Please refer to my letter dated October 20, 1980, concerning Solar Petroleum's request for a non-standard location on their Navajo "F" #147 located 10' FNL and 2630' FWL of Section 9, T31N, R17W.

SUNDRY NOTICES AND REPORTS ON WELLS

Operator SOLAR PETROLEUM, INCORPORATED			Lease NAVAJO "F"		Well No. 147
Unit Letter C	Section 9	Township 31N	Range 17W	County San Juan	
Actual Footage Location of Well: 80 feet from the North line and 2580 feet from the West line					
Ground Level Elev: 5242	Producing Formation		Pool	Dedicated Acreage: Acres

Re: Horseshoe Gallup Field Pool
Many Rocks Gallup Field Pool
Non-standard Locations

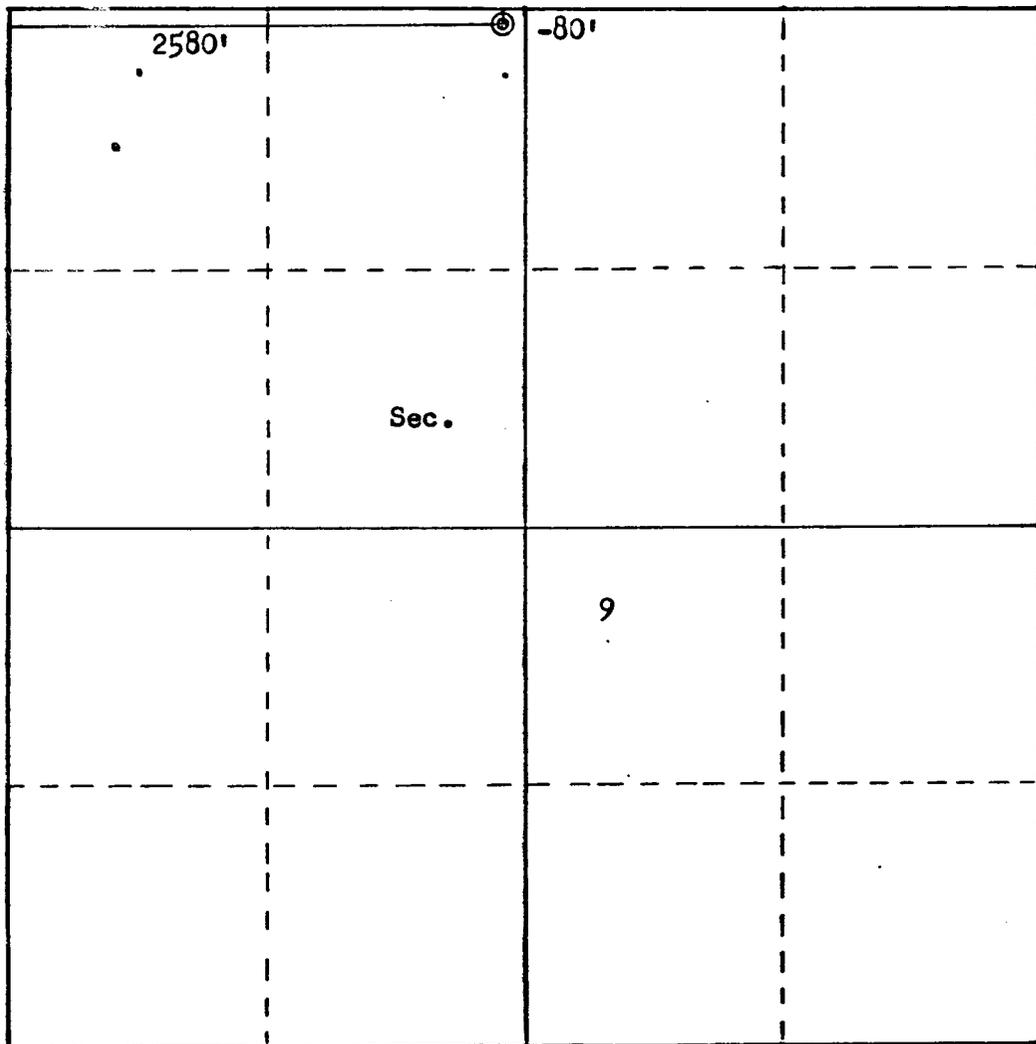
Due to this well stake being located on an existing oil pipeline, the well was moved to 80' FNL and 2580' FWL of Section 9, T31N, R17W.

Location was moved due to the original well being staked on an existing pipeline.
